# HISTORIC LANDMARK COMMISSION STAFF REPORT

## Trolley Square New Construction Petition 470-07-21: Amending the previously approved design of Building C 602 East 500 South November 5, 2008

Trolley Square Permit Plan Review: Building C Whole Foods  
October 15, 2008

EAST ELEVATION - BUILDING C  
1/32" = 1'-0"

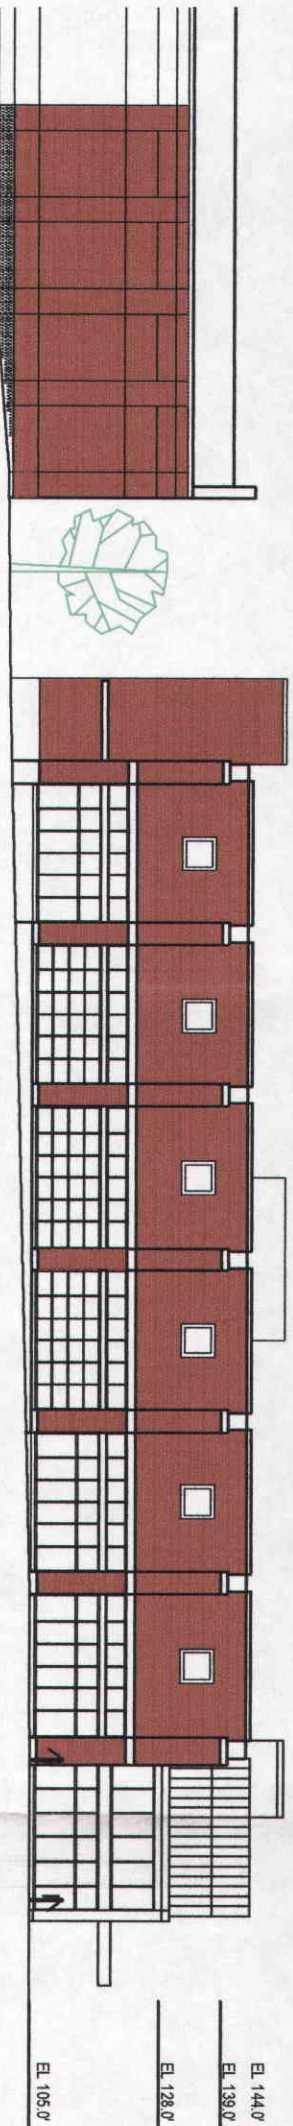
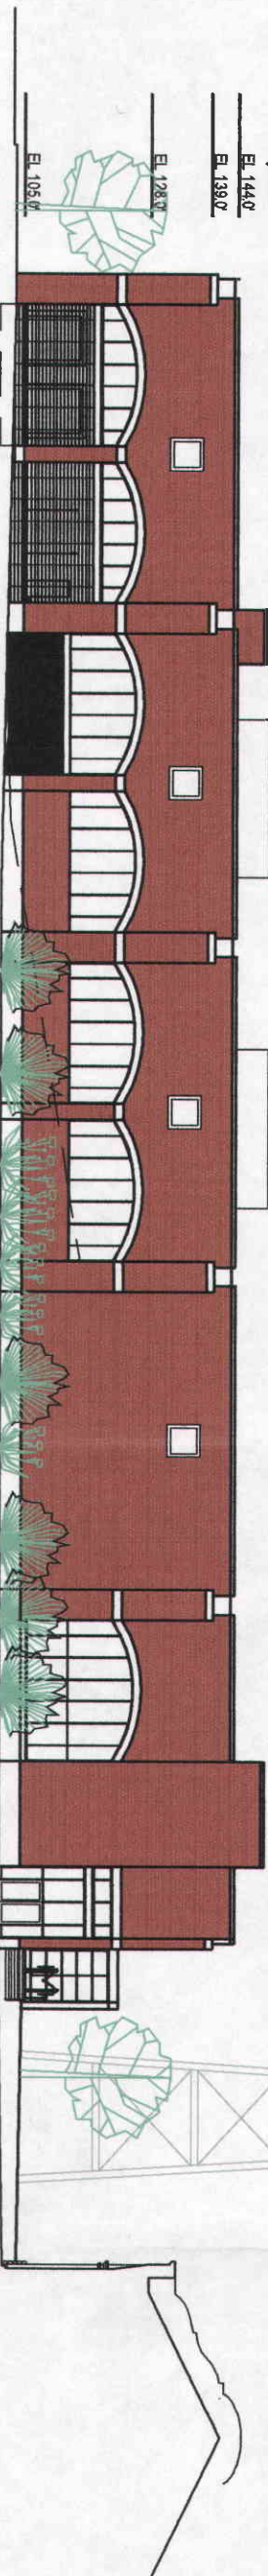
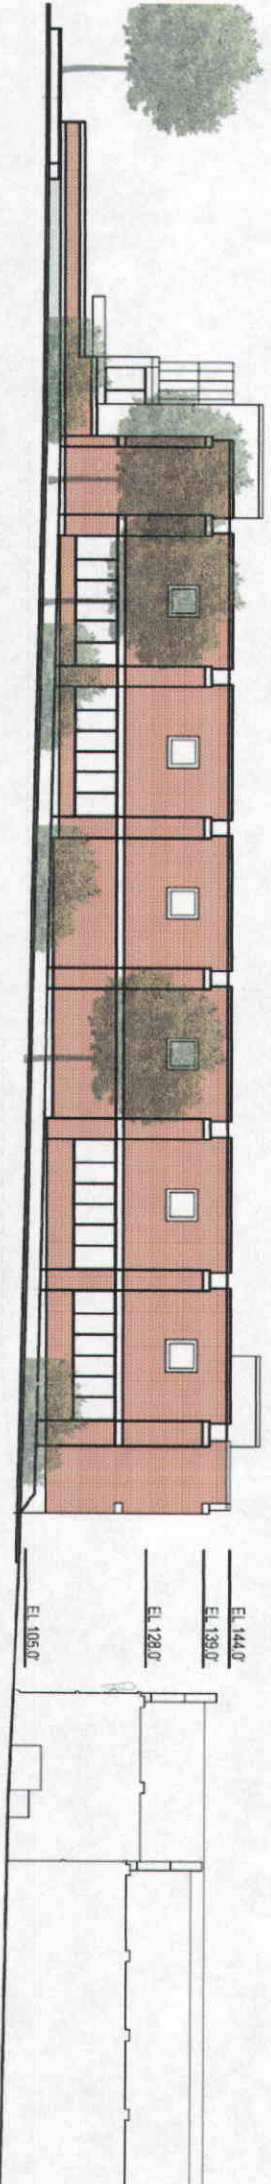
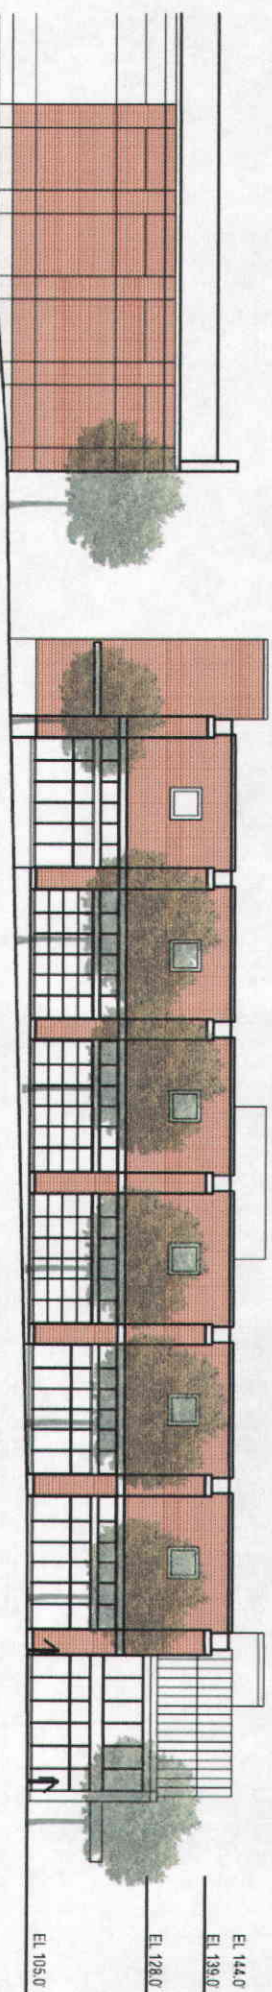
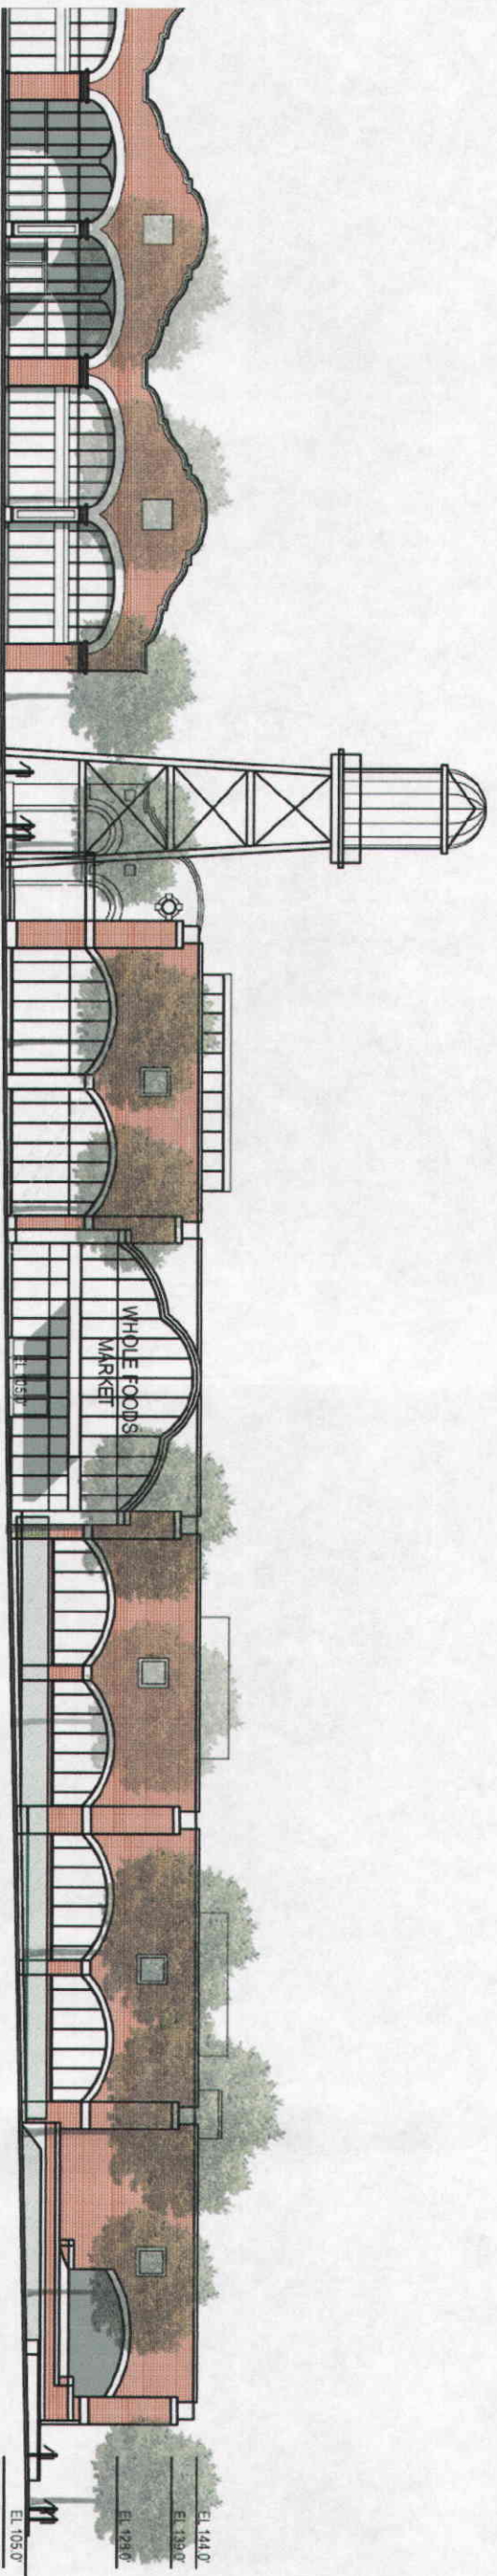
4. The approved plans indicate a different building footprint than the permit set. It appears as though the footprint along the east elevation has changed.

1. North of the main entry, the approved plan shows 4 arched window bays. Permit set shows 2 arched window bays and a staircase with glass storefront.  
**See item 4 above.**

2. On approved plans, the canopy is a flat, horizontal canopy. The canopy on the permit set is arched.

3. Approved drawings show a building height (to top of parapet) on the north corner of 39 feet. Permit shows a building height of 41'4".

4. Approved plans indicate planter boxes along the store fronts to the north of the main entry. The permit set does not include the planters.

5. The parking ramp on the approved set included a brick veneer on the ramp to the parking structure. On the site plan it is shown as a concrete wall with no veneer.

1. Approved elevations show brick columns between overhead garage doors. Permit set indicates a metal panel.

2. Approved at 39 feet, permit shows height at 41 feet above parapet.  
**See item 3 in section immediately above.**
3. Approved elevation indicated 4 bays of overhead doors. Permit set shows 3 with a stair tower.  
**The approved drawing showed only 3 doors, one in each of the three bays of the South Terrace. The elevation bay spacing has been adjusted which may account for a perceived discrepancy.**

1. On north side, arched windows above loading dock area are shown on approved plans. Not included on permit set.

2. Arched storefront above entrance to parking on approved drawings, not indicated on permit set.  
**See item 1 above.**
3. Arched storefront indicated beyond parking ramp screen wall on approved drawings, not indicated on permit set.

**See item 1 above.**
4. Section of wall that terminates Trolley Lane was approved to include visual interest. Not indicated on permit set.  
**We will install an applied piece to provide the approved visual interest. The field for locating the applied piece will be indicated on the drawings.**

5. Storefront on south corner approved to include glass to grade. Not reflected on permit set.  
**The southwest corner of the building was changed to respond to comments given by HLC regarding opening the space at the intersection of the two public pedestrian ways. In addition, the entry door was shifted to the east at the request of the tenant. We believe this is a better solution for what can be a**

1. Two storefronts shown at loading dock on approved drawings; only open grille indicated on permit set.  
**The tenant required open-air and less visibility into the loading bay. The storefront has been replaced with a light metal screen infill to partially obscure the interior of the dock space. The design team elected to eliminate one opening, but the openings and grille in the adjacent bay can be added back in.**
2. Height to top of parapet approved at 39 feet, shown at 40 feet.  
**See item 3 under East Elevation section.**
3. Parking ramp wall approved to be clad with a brick veneer, concrete indicated.  
**Brick veneer has been reinstated.**
4. Parking ramp wall approved to be stepped and parallel to grade. The ramp screen wall slopes on the permit set.  
**Ramp screen wall will be stepped parallel to grade.**

**The footprint changed to accommodate tenant requirements for escalators and a grocery parcel lift at the east elevation. This moved the solid element (an elevator at the time) to the north. The two northerly arched window openings were eliminated and a smaller flat lintel window and exit door inserted. Planting along this elevation has been intensified to mitigate the change in window exposure. The entry to the store visually and experientially has been improved with the addition of a larger column supported entry canopy extending closer to the curb and intended to display produce and flowers outside the store.**

**The approved canopy was a flat awning attached to the pavilion wall affording adequate but minimal protection while entering the store. The entry to the store visually and experientially has been intensified with the addition of a larger entry canopy extending closer to the curb and intended to display produce and flowers outside the store.**

**The approved height of 39' was taken from a finish floor level of 305' to give an elevation above grade of 344'-0". We reduced the floor elevation by one foot to 304' and increased the top of parapet by 1'-4" for an elevation above grade of 345'-4". This is a net gain of 16".**

**The vertical height increased due to a combination of technical and program realities. The finished floor elevation for the building was lowered to 304' to meet the requirements of existing grade at the east store entrance. The store requires a minimum 21' vertical clear height. The P1 parking floor required additional depth for weather insulation and it slopes to drain. Finally a structural shift to pre-cast concrete which required deeper support beams all contributed to the increase at top of parapet.**

**The intent of the team was to keep the top of parapet as low as possible. The code requires 42" high parapet for fall protection. The parapet height varies between 4'-2" and 5'-8" due to deck drainage and to effectively screen automobiles from view from the street. This height can be reduced by 8" and still maintain fall protection.**

**Planters along the east elevation were never intended nor indicated on the approved drawings. What may be confusing is that we illustrated screening shrubs as a green colored block which could be perceived possibly as a planter form.**

**Brick veneer has been reinstated.**

**The south elevation has been designed with an enclosed terrace with garage doors. This has been inconsistently shown on the approved drawings but is indicated best on the east and west elevations. The approach was to make this terrace delicate in scale and of lighter materials to provide the appropriate texture in the environment of the central plaza. The metal cladding is suggested but not labeled on the elevations. The approved brick columns are**

**The three following items are interrelated. The arched openings depend visually on being symmetrical within the major bay. At the loading dock, the dimensional requirement for the two loading bays at 25'-8" was greater than that possible within the half bay symmetry. The adjacent opening just to the south measures 22'-2".**

**Similarly, the turning requirements for entering and exiting the parking ramp pushed the entry width beyond that possible within the symmetrical condition to 33'-4". The arched openings would therefore have been odd-sized and out of character and dimension with the others on the building. This logic applies to the half-bay immediately south of the auto entry as well.**

**We elected to use a simple horizontal lintel, as we did on the north elevation, to bring visual harmony to this northwest corner of the building which can be seen when viewed obliquely. Storefront still is provided over the auto ramp entry, but not over the loading due to vertical height relationships to the horizontal lintel which wraps the entire building at the same height.**

**very active corner. The terrace at the southwest corner will be populated by customers of the store and others at key times during the day and evening and provides a larger, more inviting space at this key intersection.**

**WHOLE FOODS - SITE PLAN**  
SALT LAKE CITY, UTAH

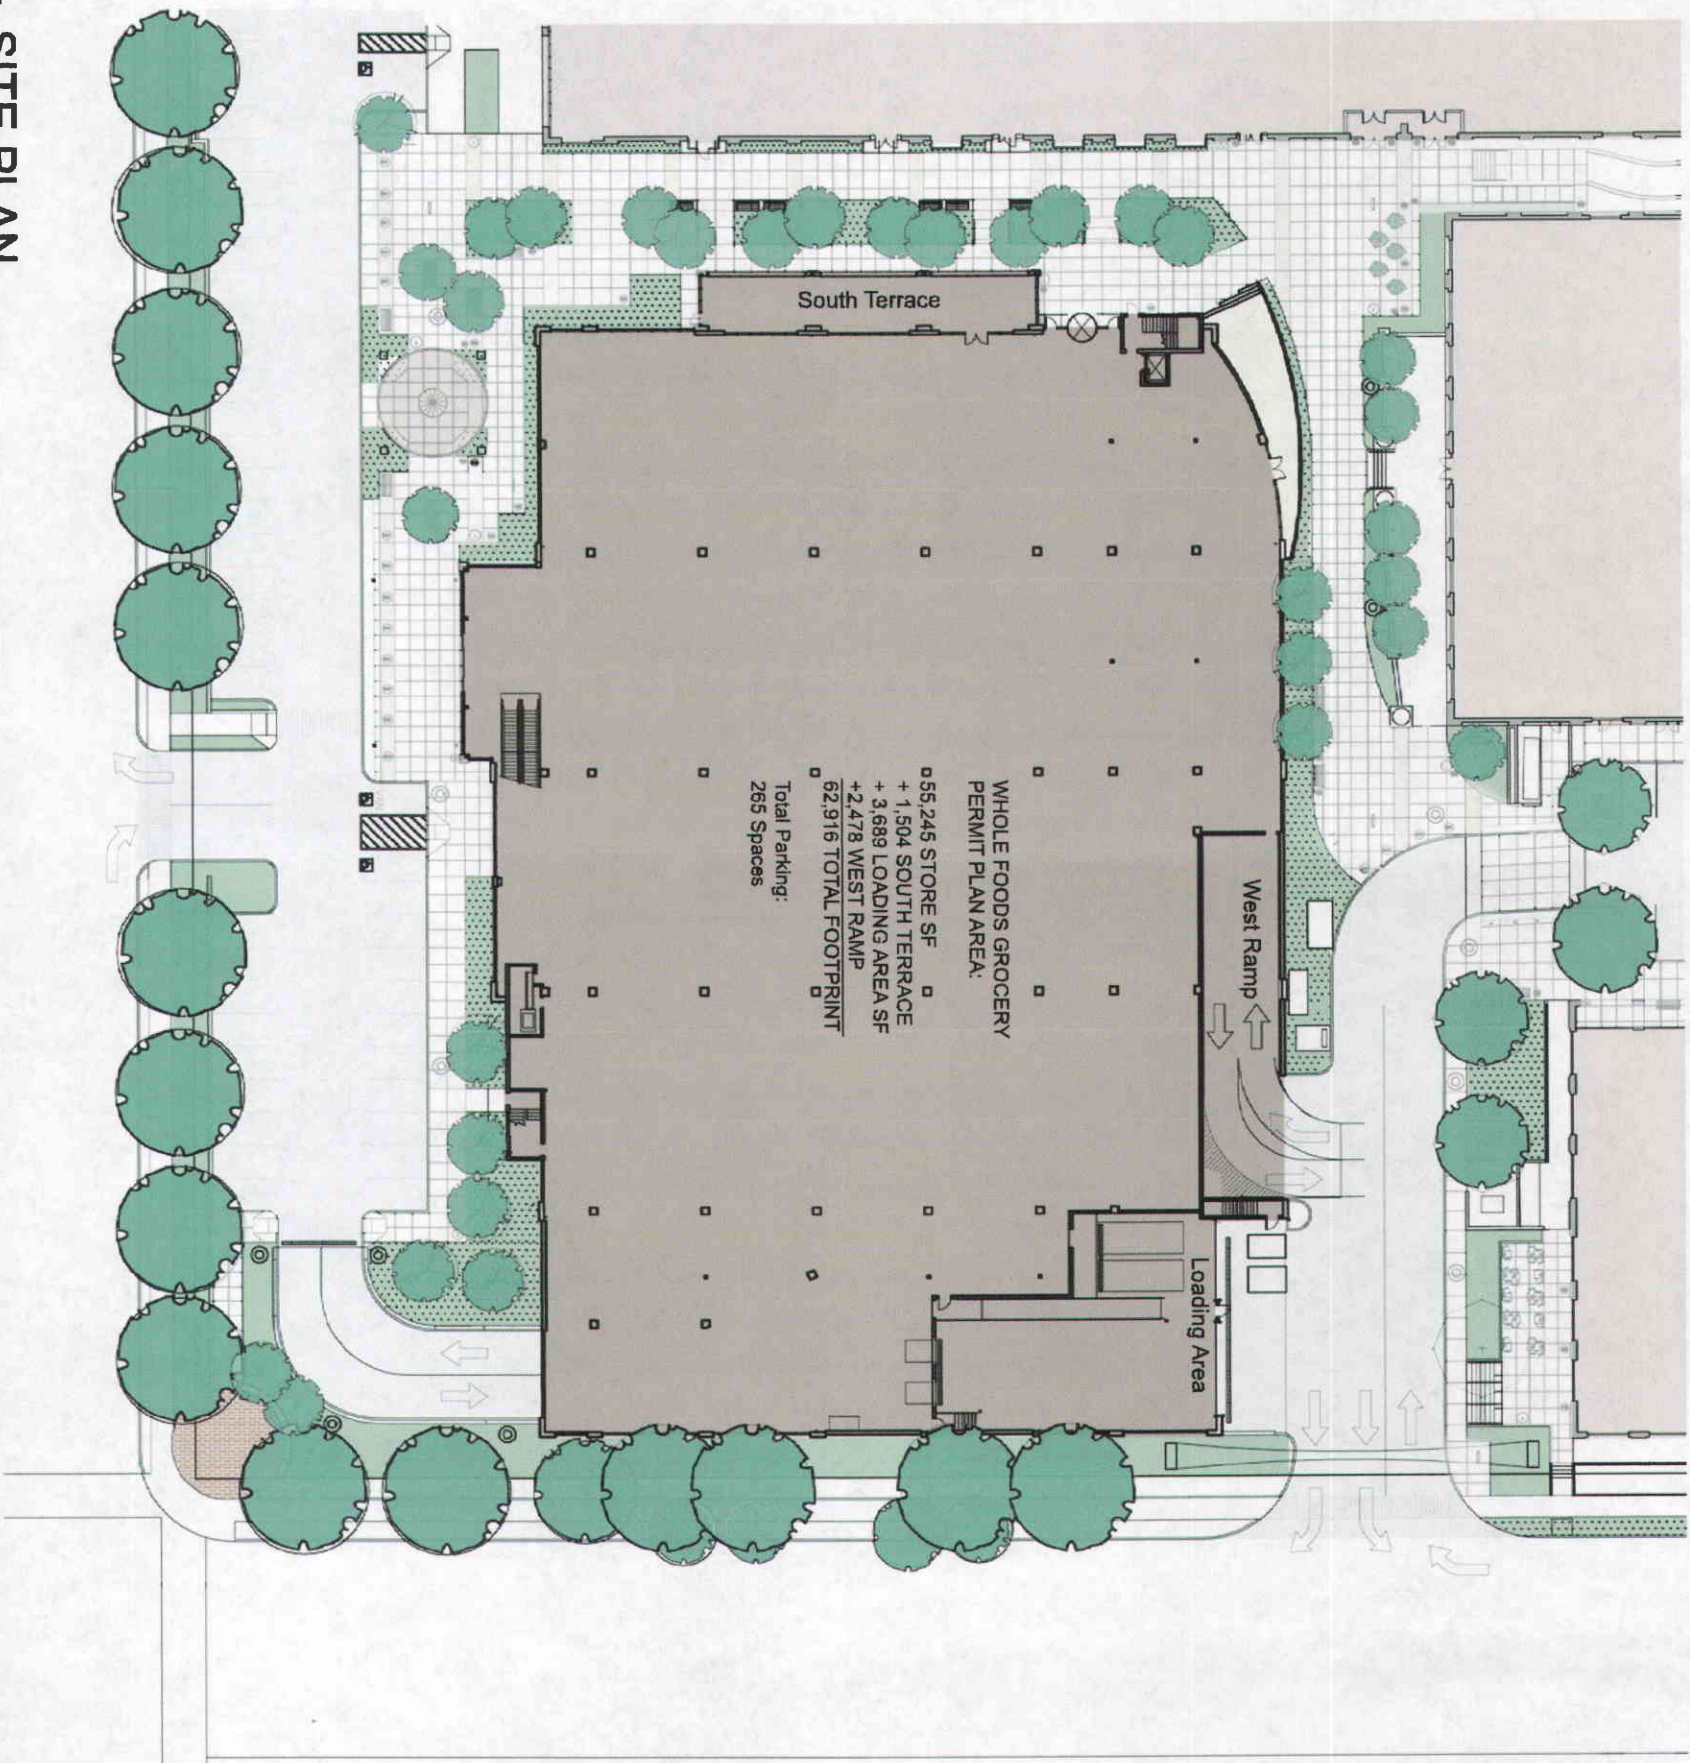
The plans submitted for a building permit indicate an increased foot print. The Building C footprint shown on the plans approved by the HLC on September 5, 2007 is 53,987 square feet. The footprint of Building C shown on the plans submitted for a building permit is 62,916 square feet. The approved square footage did not include the south porch, the western ramp up to the parking area and the enclosed loading dock area, which accounts for approximately 7,670 square feet. The actual difference between the approved footprint and the proposed footprint is approximately 1,258 square feet, or 2%. The increase in square footage is found along the east elevation north of the primary entrance. The approved building shows an internal staircase adjacent to the primary entrance and a landscaped area north of the staircase. The proposed alteration extends the east wall of the staircase approximately 80 feet further north and reduces the amount of landscaped area.

**DISCUSSION:** The additional square footage along the east elevation of the building pushes the building closer to the street than Building D. While this changes the relationship of the building and the street, it does not negatively impact the other buildings on the street. The approved site plan and building elevations include a store front that extended closer to the street than the rest of Building C and all of Building D. The additional square footage is located to the north of the entrance and therefore would not further reduce the views or the relationship between Building C and Building D. The overall spacing of structures or the relationship to the pedestrian ways along 700 East and 500 South would not change as part of this proposal.

1. The approved square footage of the footprint of the building was 52,293 and included a mezzanine for an approximate square footage of 56,293. The permit plan set shows a building footprint of 60,438.

**The 52,293 SF area referenced the gross leasable area and not the building footprint. Excluded from that area were the loading dock, west ramp and enclosed South Terrace. A more accurate footprint was shown on the parking level (P-1) plan at 60,577 SF gross area. That area should have been shown on the store level plan.**

**A composite store level plan has been developed referencing all changes from the Landmark approved plan.**
2. The Planning Commission required, as a condition of approval, scooter parking to be included within the parking structure. There are no parking stalls for scooters indicated or reflected in the parking table.
